GOVERNMENT OF INDIA
MINISTRY OF ENVIRONMENT & FORESTS
Central Zoo Authority

F. No. 19-256/93-CZA(193)(Vol. III)(M)/2050

Sub:- Construction of enclosures at Nagaland Zoological Park, Rangapahar.

Ref:- Your office letter No. FOR/WORKS-1/2001(Pt) dated 14.10.2011.

BURMESE TORTOISE ENCLOSURE PLAN

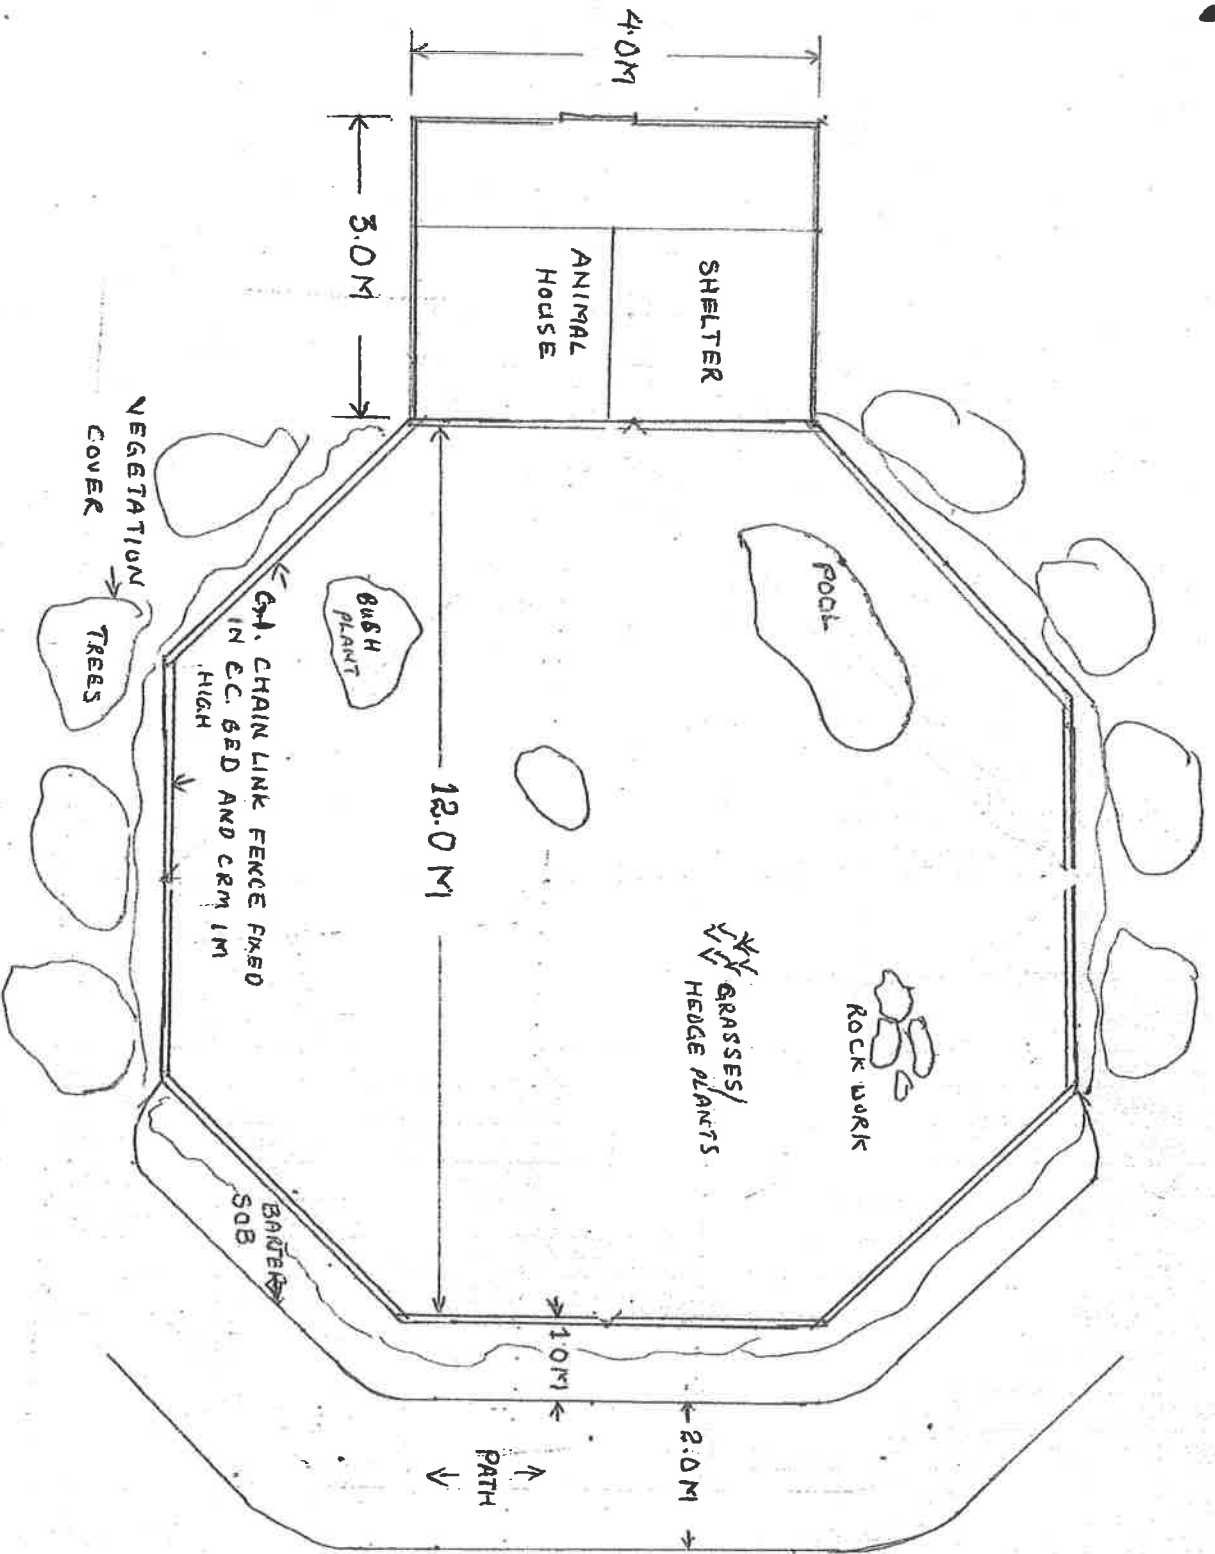
- (a) The height of the chain-link fence should be kept only 1.5 meter.
- (b) The height of the toe wall should be 0.5 meter only.
